ADDI	TION OF PORTICO AT FRONT J				
W/E	AVES OF EXISTING ROOF.				
The undersigned agrees to an extension of the statutory time limit for scheduling a public hearing <b>RECEIVED</b> Date: 3/19/2025 Applicant's Signature: VUMPreo part					
			MAR 1 9 2025		
			TOWN OF ORANGETOWN LAND USE BOARDS

#### **REFERRAL TO THE ZONING BOARD OF APPEALS**

## **NEW PORTICO AT** FRONT DOOR

## VASSILIKI ANDREOPOULOS

## DRAWING TITLE SITE PLAN **BULK TABLE**

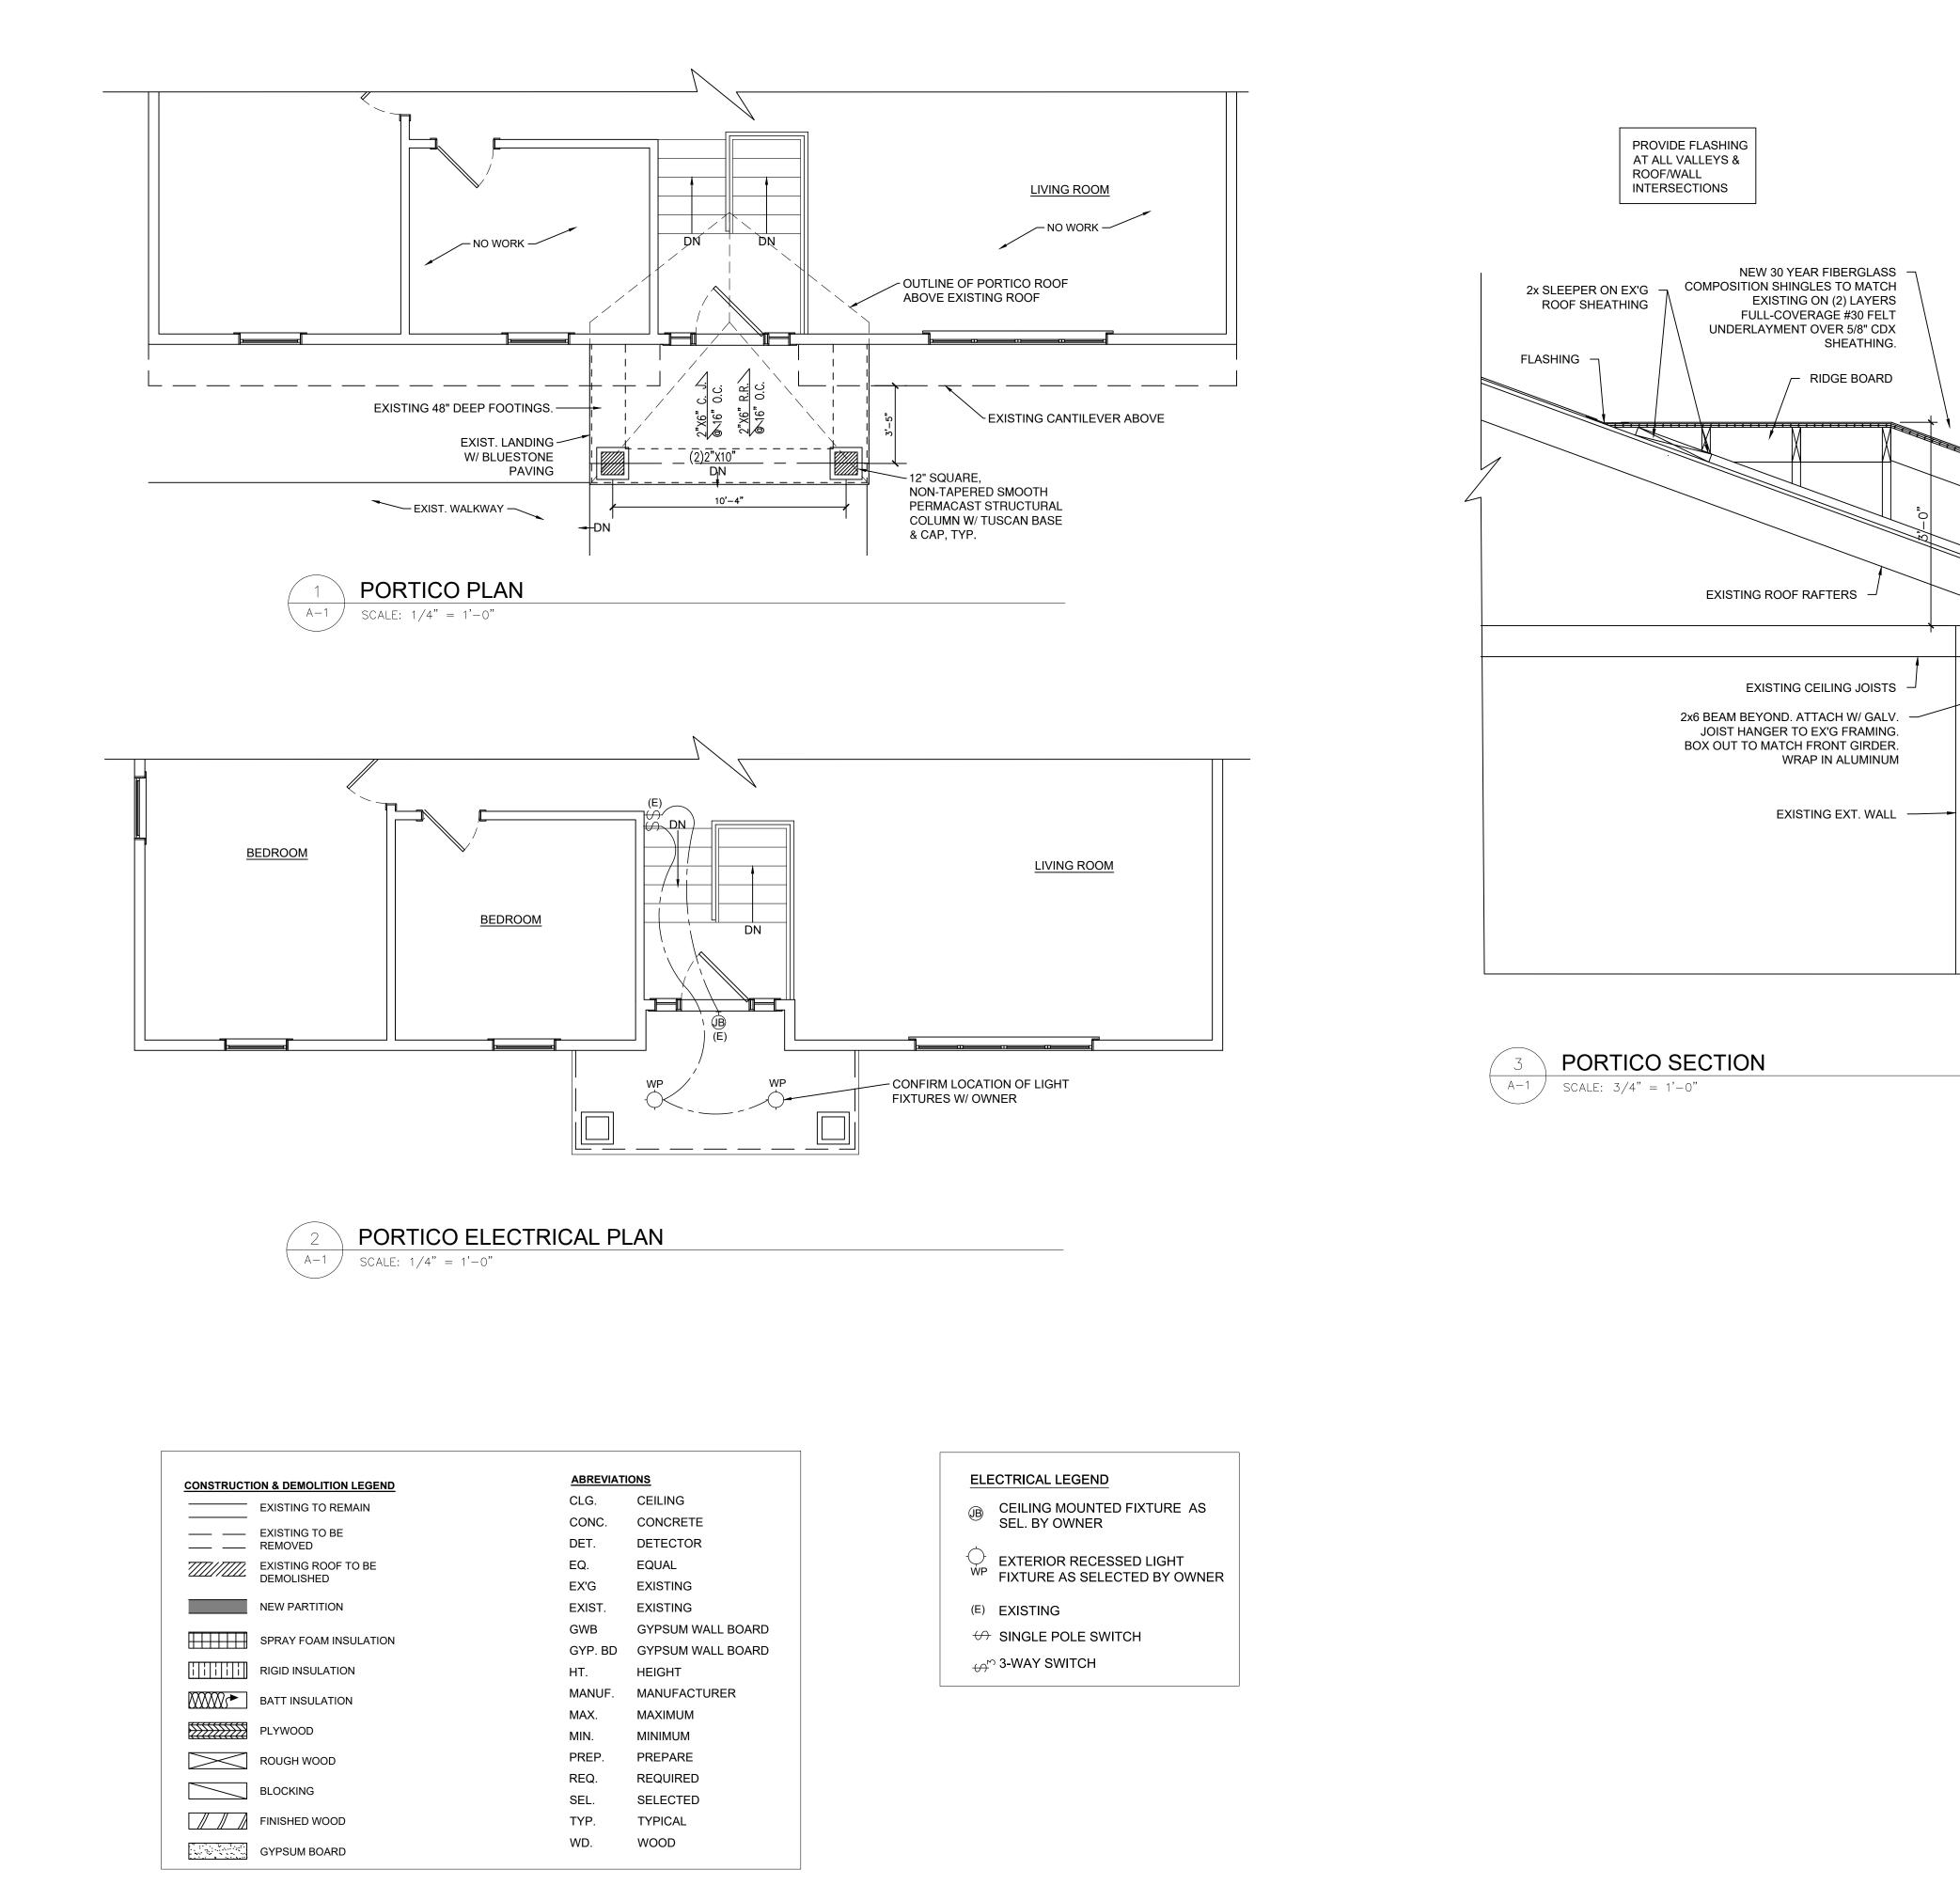
Date:	3.14.25 Andreopou		74.17	Block:	1	Lot:	4
	52 Minuterr		Drangebui	rg, NY			
RE: Applic	ation Made at:	same					
Referred For: Chapter 43,Secti 1 variances requi		Col 8, Min	imum Front	Yrd Setbacl	< 40' w/ 28.7	" propsoed	
Comments: Fro	nt Portico						
Dear Andreopo Please be advised 2.4.25		-		tt			submitted on
the Zoning Board before the board.	of Appeals, K	atlyn Bettm	ann can as	sist you in th	ne preparatio	on necessary	to appear
